Access Compliance Report

Public Rights-of-Way

(Curb Ramps)

Intersection ID: 5987	Main Street: OAK_DR	Cross Street: OAKBLUFF_CR	Location:	E
ADA ID: 5BA896C5C949	Ramp Type: Perp	Initial Pass/Fail: Fail	Overall Compliance: No	Severity Score: 1.25

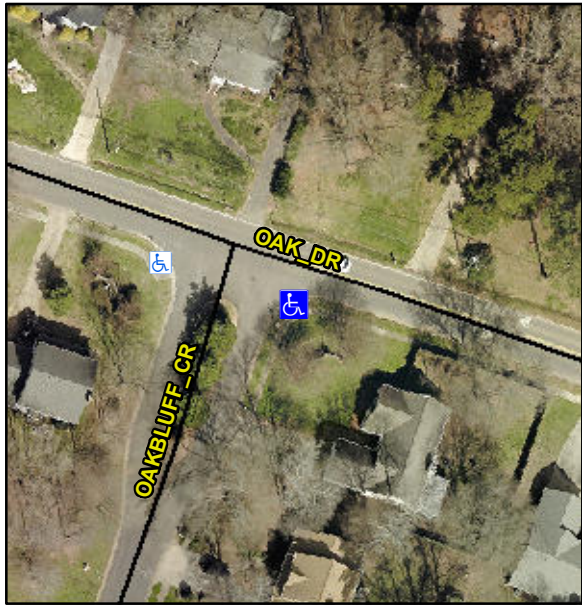
Codes/Mitigation Info/Possible Solution			Field Measurements/Component Compliance					
	Possible Solutions:		Compliance	Description	Data	Compliance	Description	Data
	Remove & Replace Entire Ramp.		N/A	Ramp Length (in)	101.0	Yes	Ramp Slope (%)	5.3
			Yes	Ramp Width (in)	48.5	No	Ramp XSlope (%)	4.6
			N/A	Flare Type LT	N/A	N/A	Flare Type RT	N/A
			N/A	Flare Slope LT (%)	N/A	N/A	Flare Slope RT (%)	N/A
			N/A	Flare Traversable LT?	N/A	N/A	Flare Traversable RT?	N/A
			N/A	Landing Length (in)	N/A	N/A	DWS Provided?	N/A
			N/A	Landing Width (in)	N/A	N/A	DWS Contrast?	N/A
			N/A	Landing Slope (%)	N/A	N/A	DWS Length (in)	N/A
			N/A	Landing X Slope (%)	N/A	N/A	DWS Full Width?	N/A
Surveyor Notes:		N/A	N/A	Landing Curb? (Y/N)	N/A	N/A	DWS Offset (in)	N/A
PROW/ADA:		Not Found, R304.5.3	N/A	Shared Landing?	N/A			
			N/A	Gutter Ponding?	N/A	N/A	Gutter Slope (%)	N/A
			N/A	Gutter Lip Ht (in)	N/A	N/A	Gutter X Slope (%)	N/A
